Camden Residents' Action Group

29 September 2025

**Re: John Street Project
Draft Concept Designs for John Street, Camden**

Source: Extract from UDF manual (pp. xii; xiii)

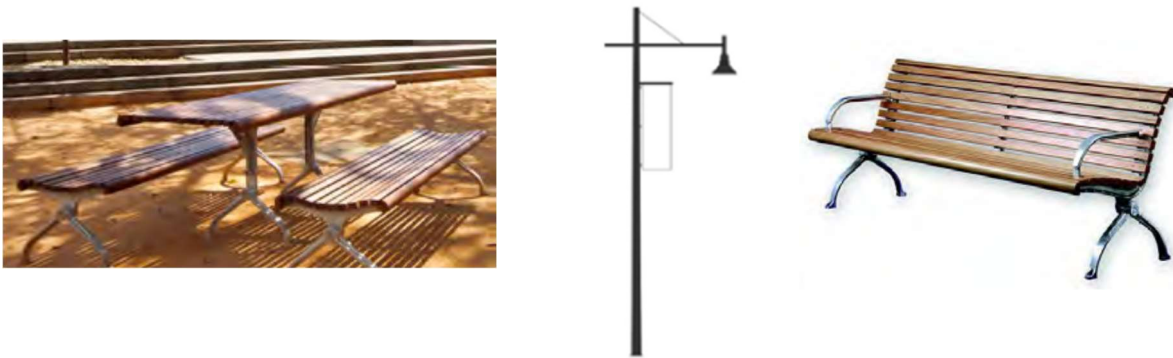
The community at the time did not consider the new furniture an upgrade, nor as high quality as that it replaced. Like ubiquitous grey granite paving, the new furniture is seen as modern generic.

Our response is that the new furniture will not make a positive contribution to the town's special sense of place and we strongly suggest something more appropriate be incorporated.

We strongly suggest that instead of mimicking Argyle Street that further investigation be undertaken into an option for John Street of interpretive and reflective street furniture and more substantial and elegant lighting as expected in a heritage town.
